**CULTURAL RESOURCES OFFICE
 PRESERVATION BOARD
 REGULAR MEETING
 MONDAY MARCH 24, 2014 — 4:00 P.M.
 1520 MARKET ST. #2000
www.stlouis-mo.gov/cultural-resources**

DATE: March 24, 2014
ADDRESS: 4321 Maryland Avenue
ITEM: Preliminary Review: construction of a new single-family house
JURISDICTION: Central West End Historic District — Ward 18
STAFF: Jan Cameron, Cultural Resources Office

DATE: March 24, 2014
ADDRESS: 2125 Cherokee Street
ITEM: New Application to construct a 2-story rear addition.
JURISDICTION: Cherokee-Lemp Local Historic District — Ward 9
STAFF: Andrea Gagen, Cultural Resources Office

DATE: March 24, 2014
 ADDRESSES: 721 N. Kingshighway and 5016 Enright Avenue
 ITEM: Demolition of two buildings prior to the construction of a commercial building
 JURISDICTION: Mount Cabanne Raymond Place National Register Historic District — Ward 18
 STAFF: Jan Cameron, Cultural Resources Office

FRONT ELEVATION

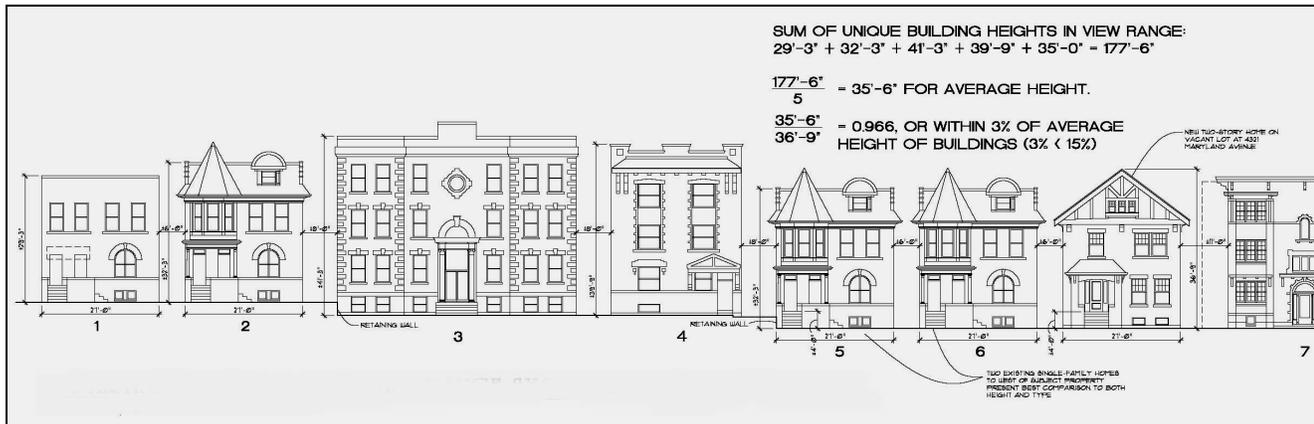
Complies. The cornice will be at the same height as that of the 2-1/2 story house to the west; floor-to-ceiling heights will be similar.

Complies. The front elevation is proposed to be a brick veneer, which will return 6 feet on the west and 11 feet on the east elevation. The front gable will be filled with false half-timbering, following an example building in the district.

PROPOSED ADDITION WITH 16-FOOT VEHICLE DOOR

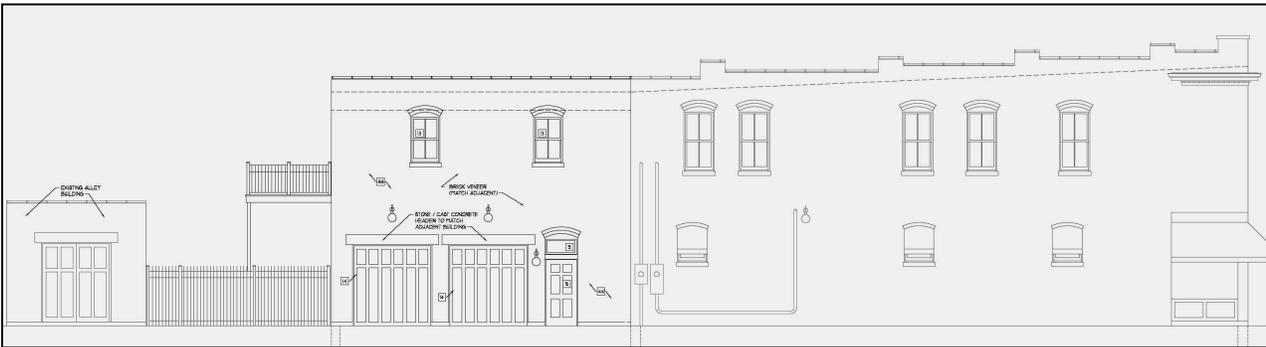
Does not comply. The addition will have a wide 16-foot vehicle door facing Missouri and second story windows that are shorter than those of the existing structure.

- The addition does not comply with the Cherokee-Lemp Historic District Standards in the proportions of openings on the Missouri elevation.
- The addition does comply with all other district standards, which do not specifically prohibit front-facing vehicle doors.

KINGSHIGHWAY ELEVATION

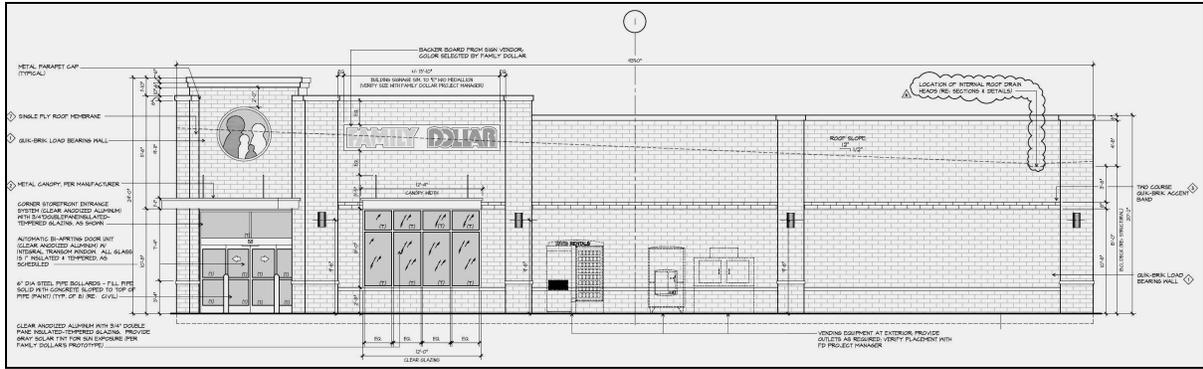
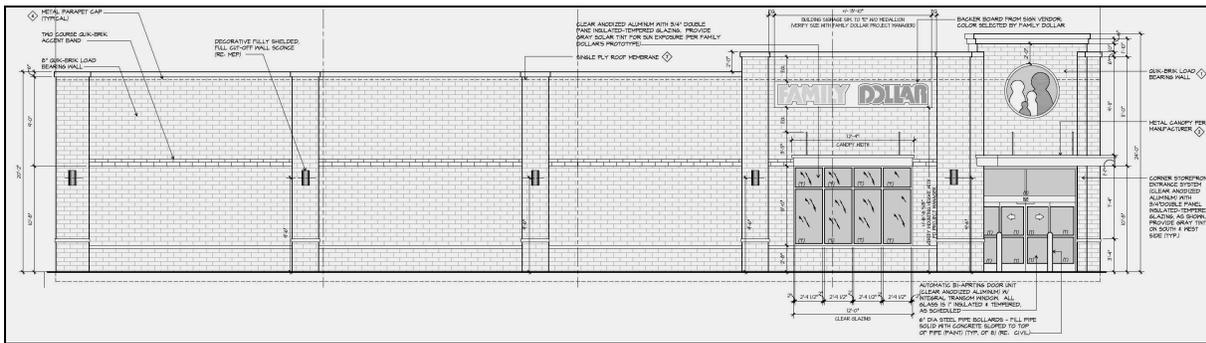
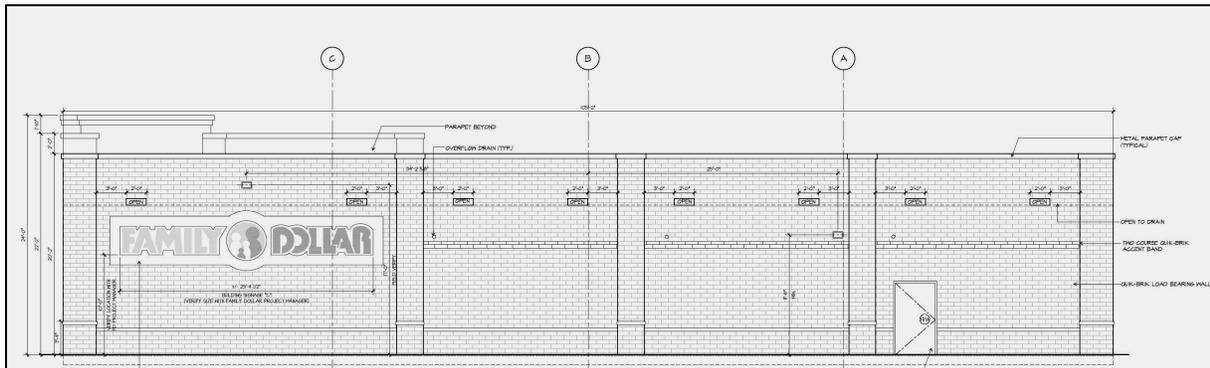
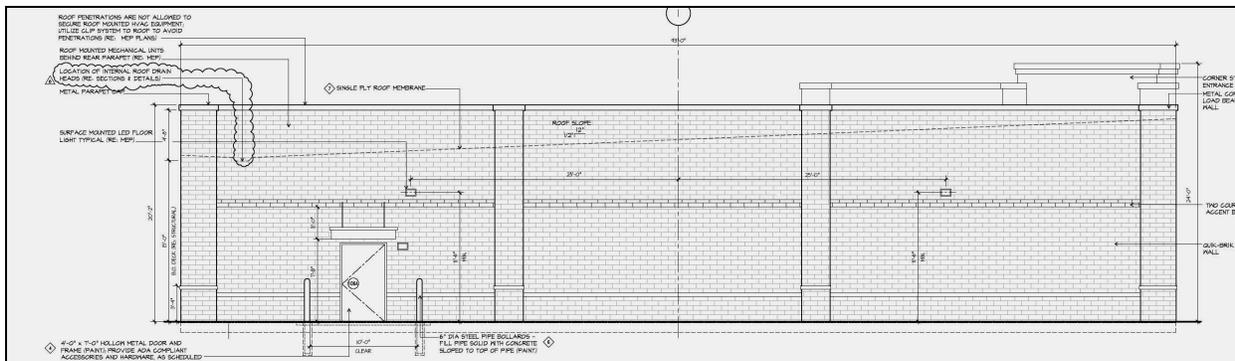
The proposed Family Dollar store will have four sides of brick and be sited at the corner of Kingshighway and Enright, with parking to the south side and rear of the building. It appears completely compatible with the motor-vehicle-oriented businesses along Kingshighway. Siting it at the extreme northeast corner of the property will enhance its separation from the context of the historic district.

- While the proposed new construction is of brick and will be sited at the extreme northeastern corner of the property, the furthest point from the historic district, it will have some impact upon the district. The trash enclosure and a storm water retention basis are planned to be located on the western property line, close to the extant historic residences.

The Cultural Resources Office recommends that the Preservation Board allow the demolition of 721 N. Kingshighway and 5016 Enright Avenue, with the stipulation that the Cultural Resources Office withhold approval of the demolition permit for 721 N Kingshighway until a plan for a substantial landscape screen at the western edge of the property, including, but not limited to, upper-story trees, fencing and other appropriate sight barriers, is submitted to the Office for approval and is included as an addendum to the current building permit.

PROPOSED WINDOW ALTERATION FROM ALLEN

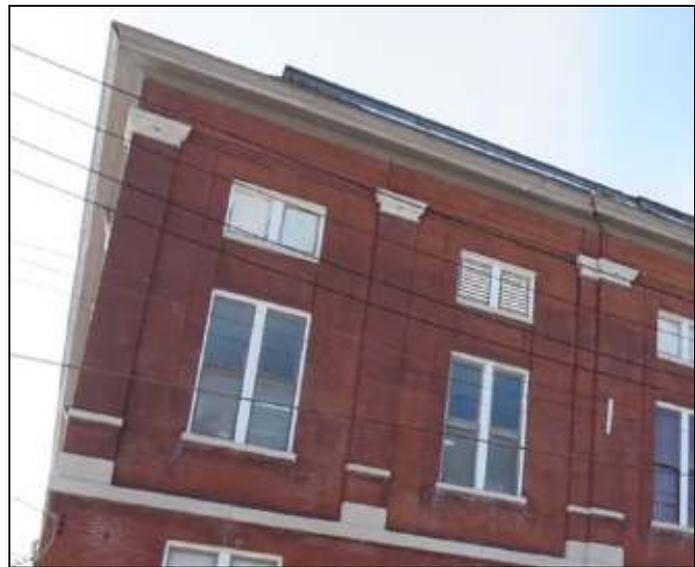
Does not comply. The original windows are proposed to be replaced by a louvered vent system for a kitchen exhaust fan which will block up one pair of five, identical paired casement windows on the building's primary facade. The vents are not based on a historic model example and adversely affect the building's historic character.

Does not comply. As noted above, one pair of casement windows of a row of eight is being blocked with a louvered vent system. This eastern elevation, while considered a Semi-Public Façade, is highly visible from both Allen and 8th Street.
